## **TUTTLE ADDITION SUBDIVISION, RESUBDIVISION OF LOT 20 SQUARE 6**

APPLICATION NUMBER 6 DATE November 19, 2015  
APPLICANT Tuttle Addition Sudivision, Resubdivision of Lot 20 Square 6  
REQUEST Sudivision

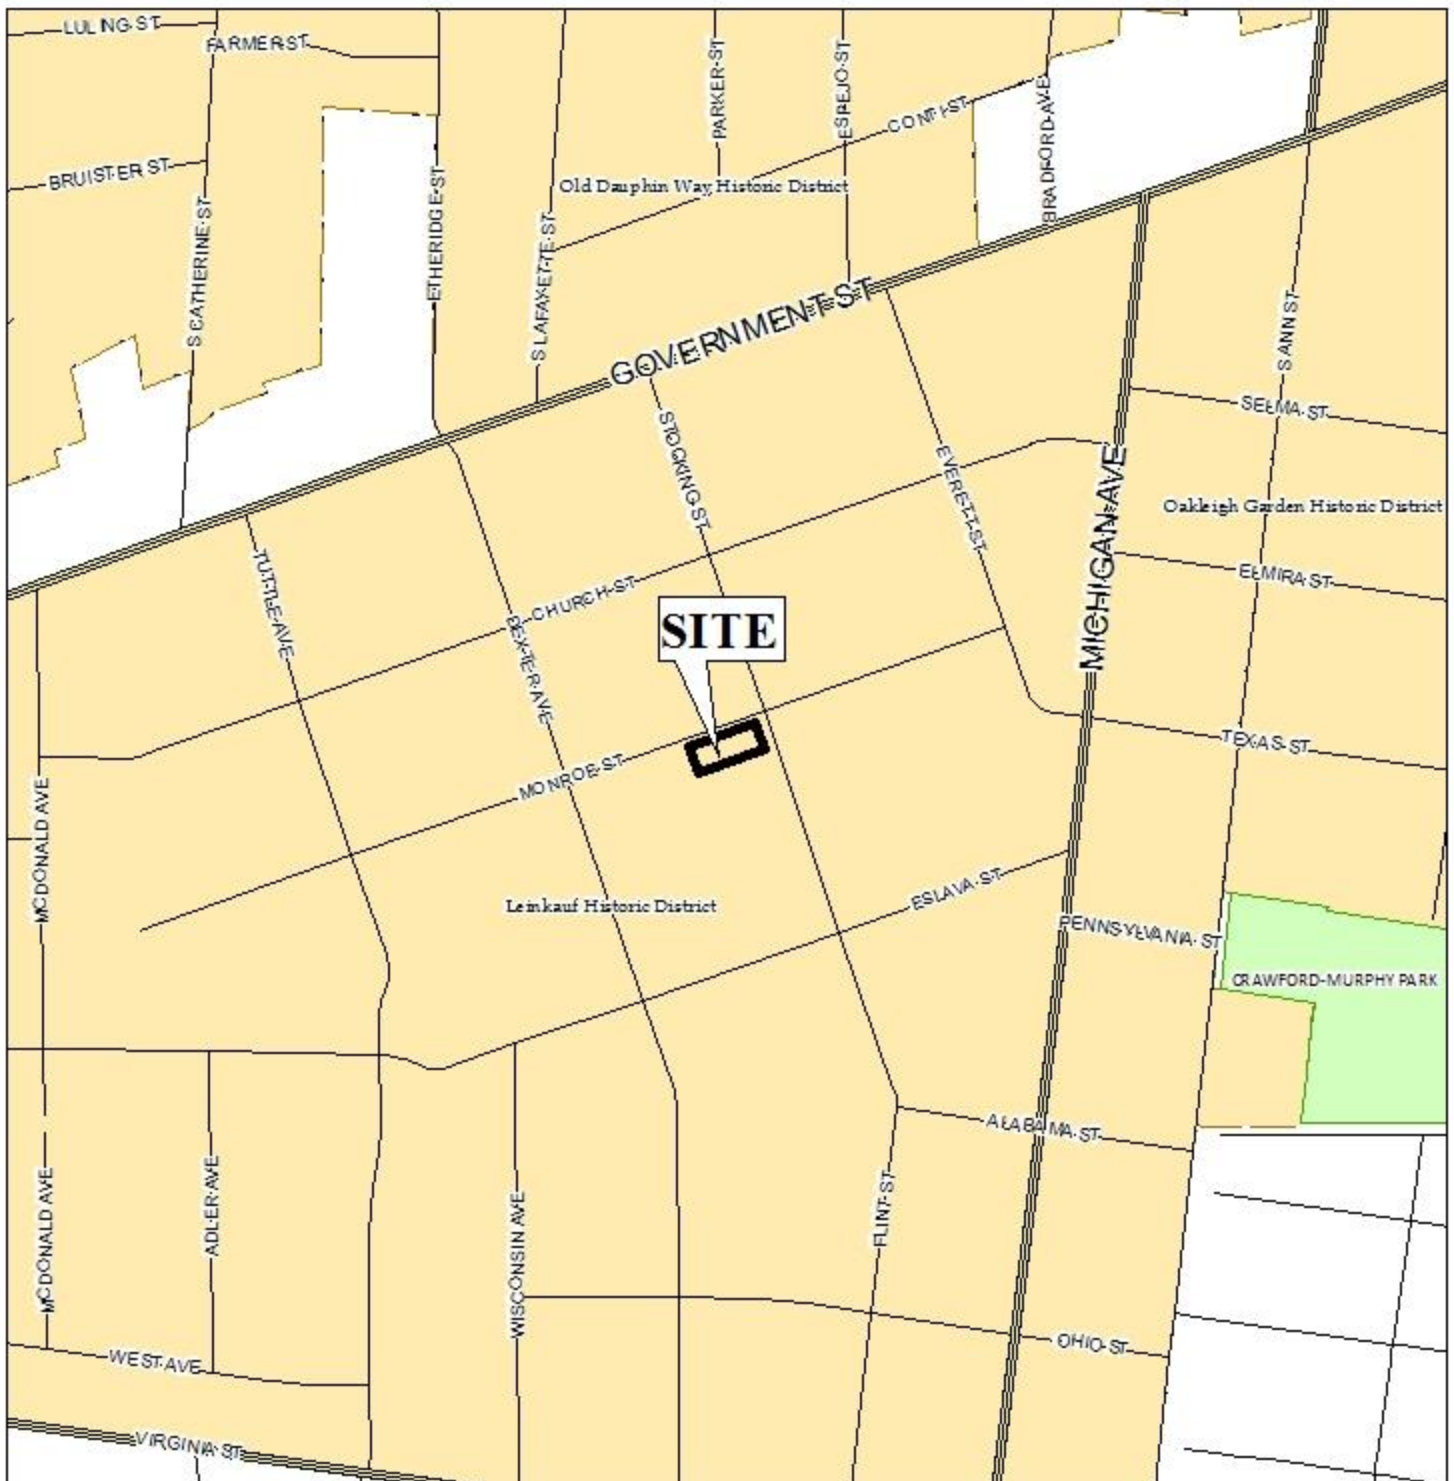
The site has frontages onto Monroe Street and Stocking Street, both minor streets with curb and gutter. Both roads are illustrated as having existing compliant 50' rights-of-way, making no dedications necessary. However, dedication of the corner radii at Monroe Street and Stocking Street per Section V.D.6. of the Subdivision Regulations should be required.

The 25-foot minimum building setback line, required in Section V.D.9., is not shown on the preliminary plat. The setback should be illustrated on the Final Plat, if approved.

It should be noted that the existing lot is currently developed with two buildings, and currently enjoys non-conforming status as a commercial development located in an R-1, Single-Family Residential District. As proposed, each of the proposed lots would have one building, which appear to occupy nearly the entire sites. A variance was granted for 1455 Monroe Street (the proposed Lot 20A) at the Board of Zoning Adjustment's July 22, 1996 meeting to allow the expansion of a restaurant into the entire existing structure with insufficient off-street parking. A condition of that approval was that there be no additional uses or building expansions until adequate parking is provided. It should be noted that variances are site plan specific and therefore any future commercial uses on either lot would require a new variance.

The proposed lot sizes are provided in square feet, and would not meet the minimum required lot size of 7,200 square feet in Section V.D.2. of the Subdivision Regulations. Despite the fact that the site is in an older part of the City of Mobile, and there are several sub-standard lots in the area, around 6,300 square feet at the smallest, the proposed subdivision would result in lots that would be 3,948 and 3,726 square feet each, which is substantially smaller than any other lots in the vicinity. The applicant did not provide any justification for the creation of these two sub-standard lots.

Based upon the preceding, the application is recommended for Denial, due to the following:

- 1) the proposed lots do not meet the minimum size requirement of Section V.D.2. of the Subdivision Regulations
